Comment Received From: David Calabrese
Submitted On: 7/28/2021
Docket Number: 21-BSTD-01

Daikin Comments-CEC Title 24-2022-15-day Express Terms

(Submitted electronically to Docket 21-BSTD-01: Daikin Comments on 15-Day Language of Proposed Draft 2022 California Energy Code)

Figure 1. Ducted and Ductless VRF Indoor Units

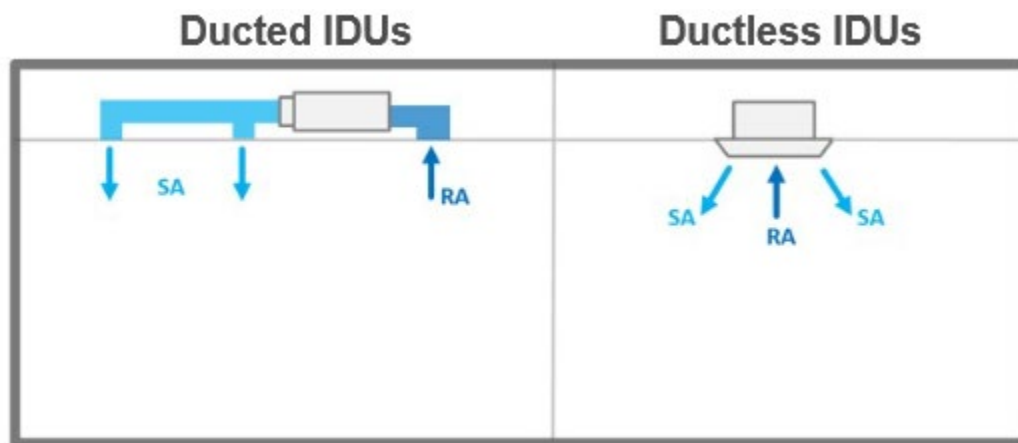
Daikin reiterates that imposing an economizer requirement for VRF indoor units raises significant and severe installation barriers. Typically, VRF indoor units are categorized as either: (1) ducted indoor units; or (2) non-ducted (i.e., ductless) indoor units. Definitions for these categories can be found in AHRI Standard 1230³. For ducted indoor units, the ductwork is often limited with little-to-no ducting for return or supply air within a single zone. For ductless indoor units, return air and supply air are passed through the indoor units without any ductwork. Figure 1 provides with a visual representation of the two indoor unit categories. Daikin reemphasizes that VRF ductless indoor units are physically unable to incorporate the use of economizers.
